RECEIPT DATE: 7/17/2018 **ONSITE SEWAGE DISPOSAL SYSTEM** P 563960
 APPROVAL DATE: 07/20/2018 **PERMIT: CONSTRUCTION** A _____
 PROPERTY ADDRESS: 2425 Miller's Mill Road, Cooksville, MD 21723
 SUBDIVISION: Tax Map 14, Parcel 30 LOT: N/A TAX ID: 04-322932
 CONTRACTOR: Sam's Creek EMAIL: Sams.Creek@aol.com
 CONTRACTOR ADDRESS: 2810 Sams Creek Road, New Windsor 21776 PHONE: (443)821-4932
 PROPERTY OWNER: Joseph J Spellman EMAIL: Spellmans4@verizon.net
 OWNER ADDRESS: 1800 Highfield Road, Ashton, MD 20861 PHONE: (301)661-6413
 SEPTIC TANK SIZE (GALLONS): 2000 TANK MANUFACTURER: Mayer Bros., Inc.
 PUMP MODEL: N.A. PUMP SIZE: N.A. PUMP TANK CAPACITY: N.A.

RE: **Variance request**
2425 Millers Mill Road
Cooksville, Maryland 21723

PROJECT: SPELLMAN PROPERTY
2425 MILLERS MILL ROAD
COOKSVILLE, MD 21723

TITLE: ONSITE SEWERAGE DISPOSAL SYSTEM DESIGN PLAN

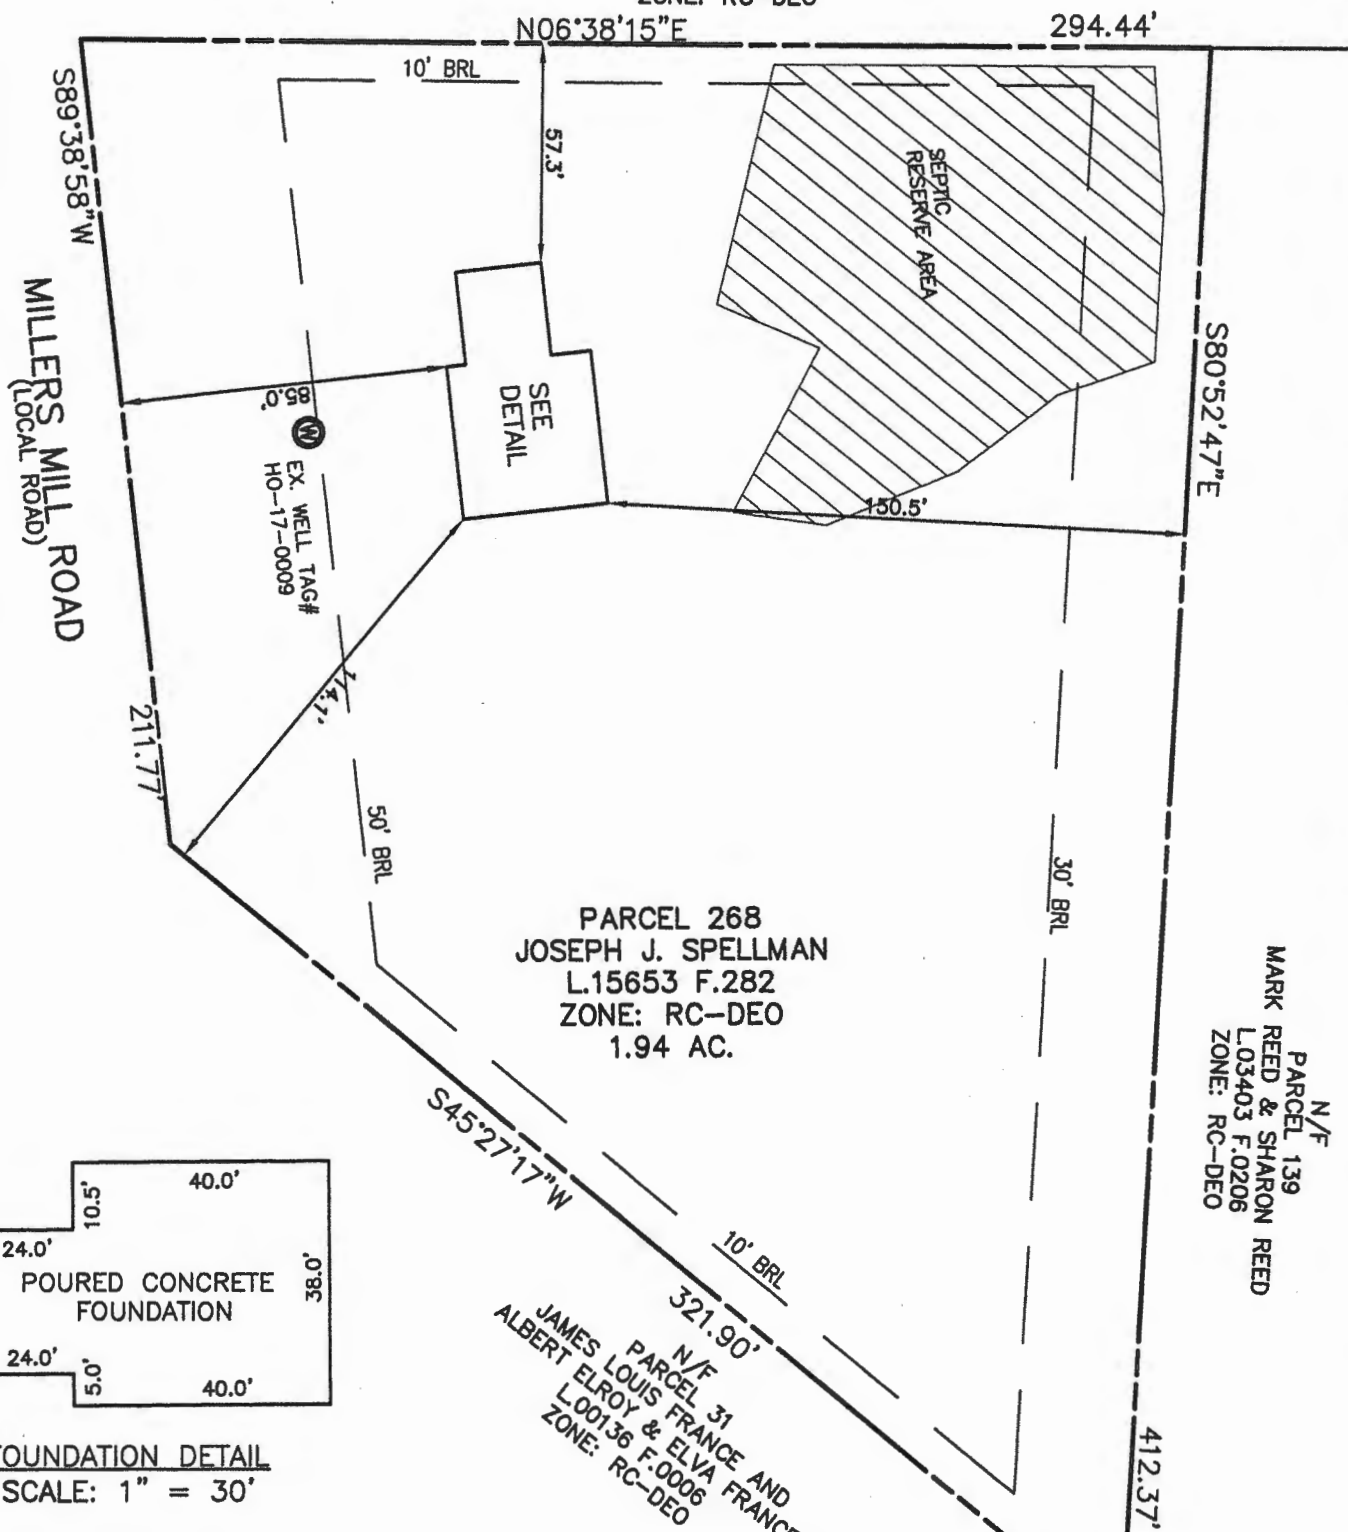
7/19/2018 D BOX SHIFTED TO CENTER OF SDA FOR FUTURE REPLACEMENT SYSTEMS. TRENCHES SHIFTED DOWN, S.T. BE ANGLED AND MOVED JUST OUTSIDE 100' RADIUS FROM HO-17-0009.

7/19/2018 (PM) SHC AND SEWER LINE TO TANK INSTALLED. S.T SET AND LOWEST TRENCH DUG. REINSPECT TANK BAFFLES, D. BOX, AND TRENCH CONSTRUCTION. 7/20/2018 TRENCHES INSTALLED TO SPEC. D BOX LEVELED. D BOX IS SMALL 3 PORT BOX. CORRECTIVE ACTION FOR LEAK IN D BOX LATERAL CONNECTION COMPLETED IN FIELD. LEAK PLUGGED WITH CEMENT. OK TO BACKFILL.

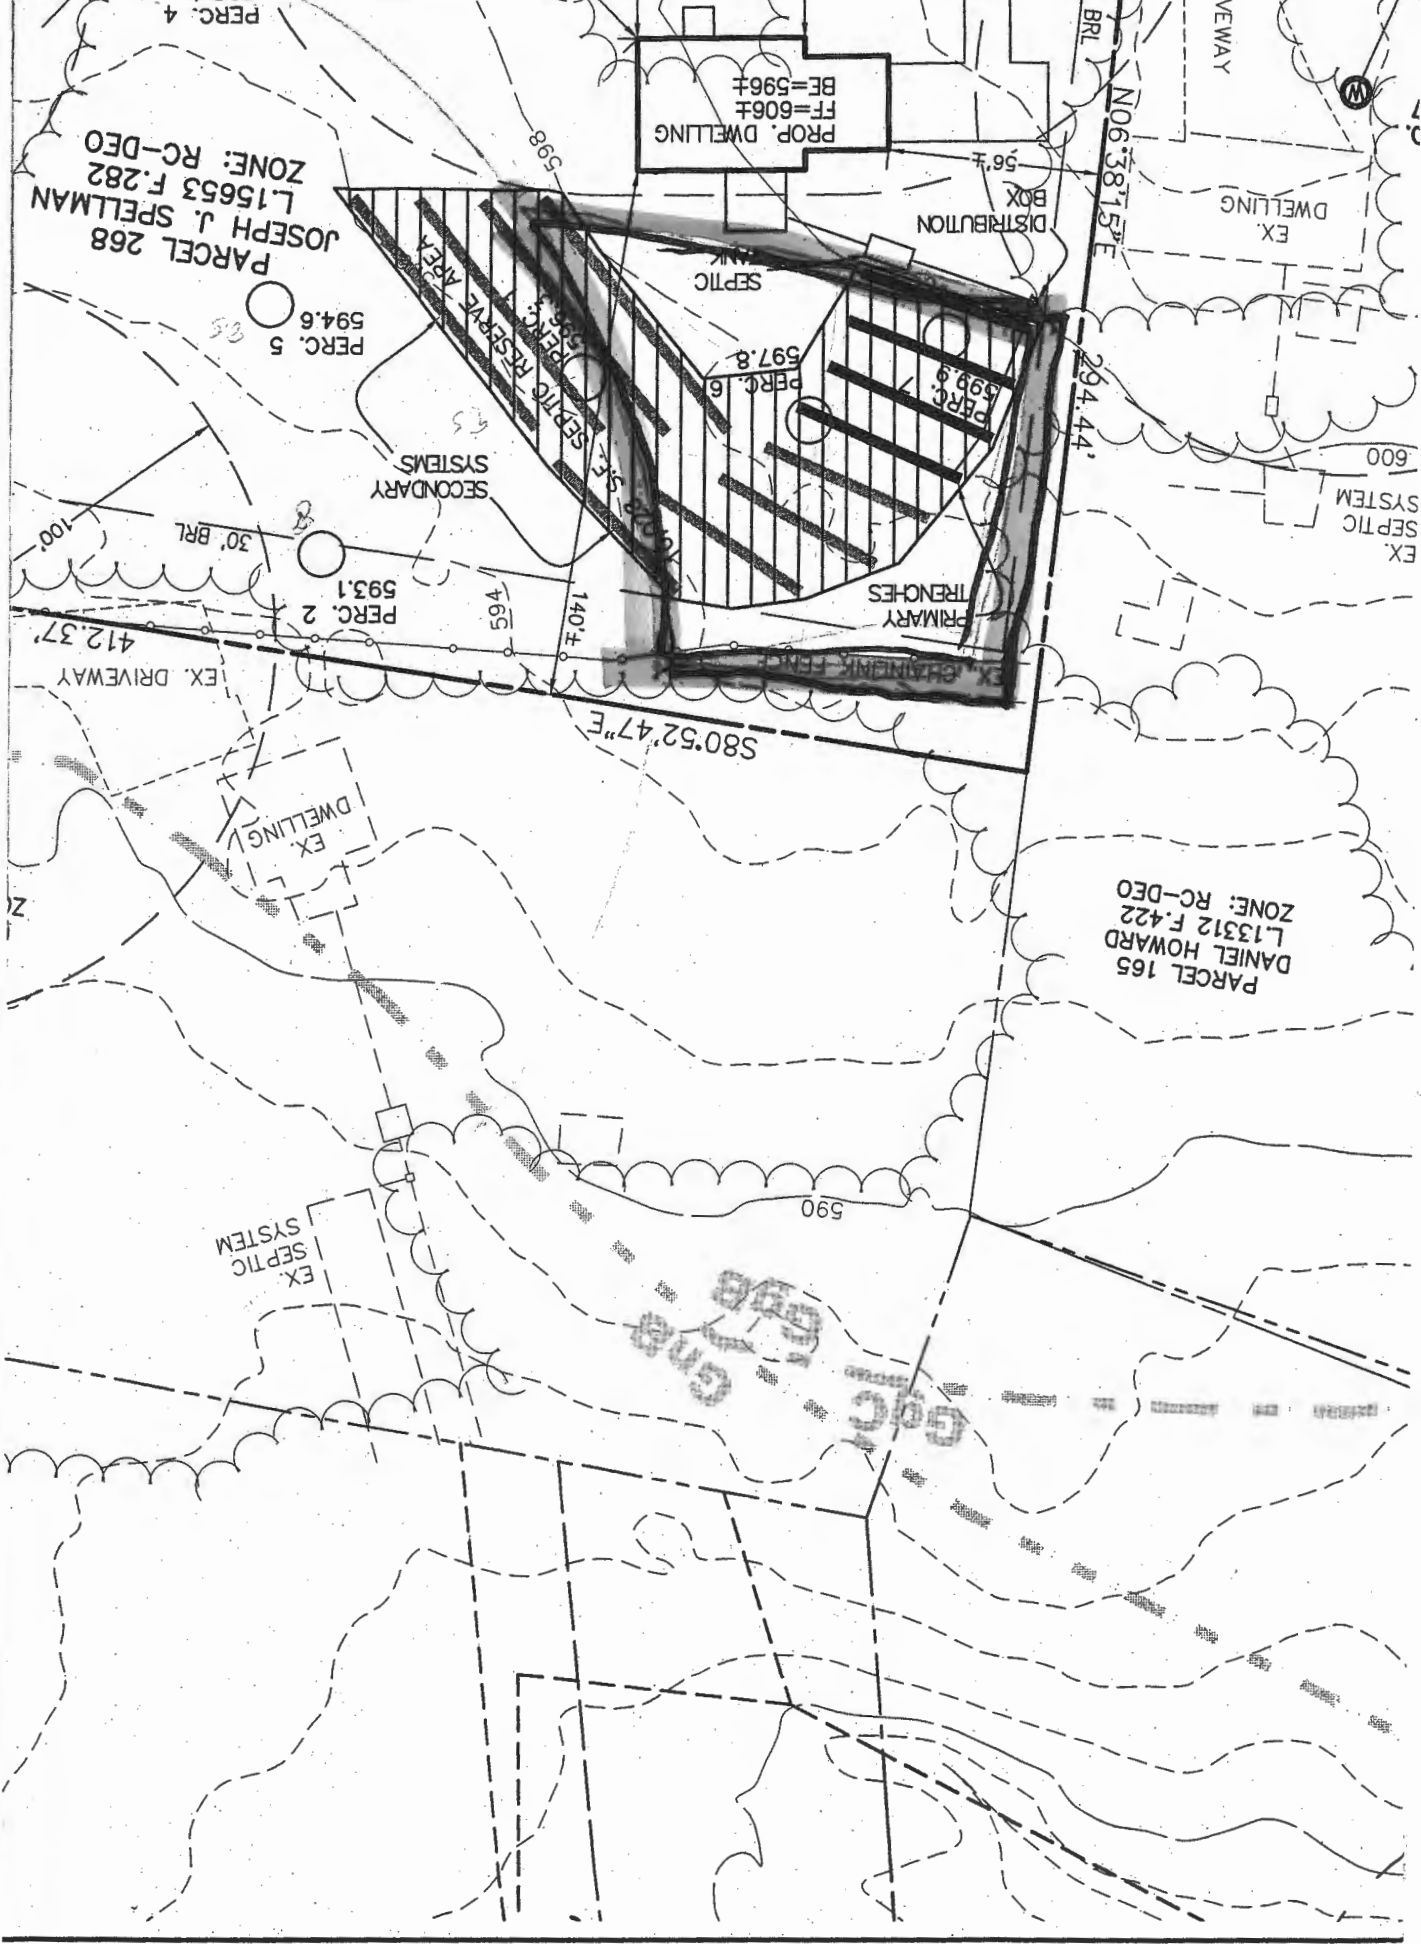
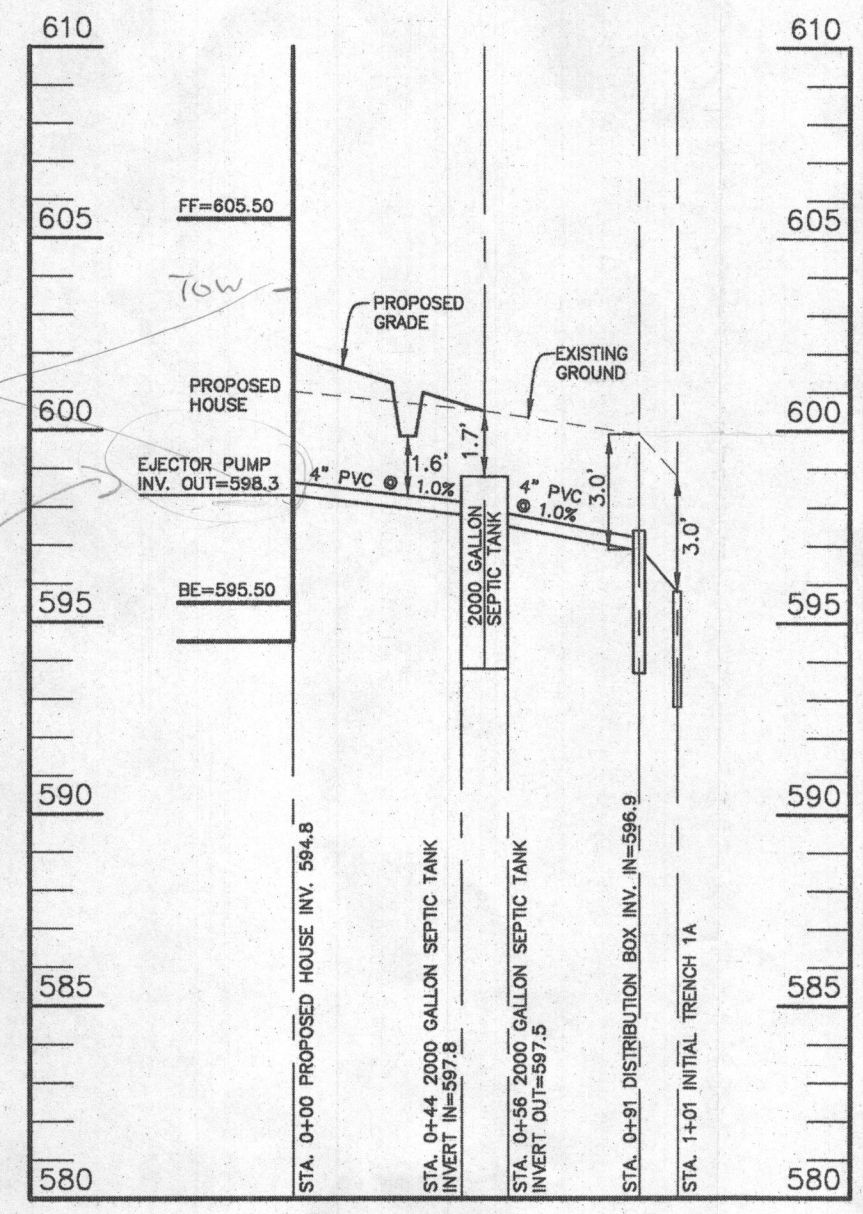
- Notes:
- check well
 - verify S&A
 - ie. measure at house, at two ends
 - scale off 100' at well area -> tank must be 100' (25' off house)
 - verify show @ house. Hang curer approx. 6' below TOW
 - location of sewer out at house
 - short. Elevation for pipe fall from house
 - start to check existing for trench
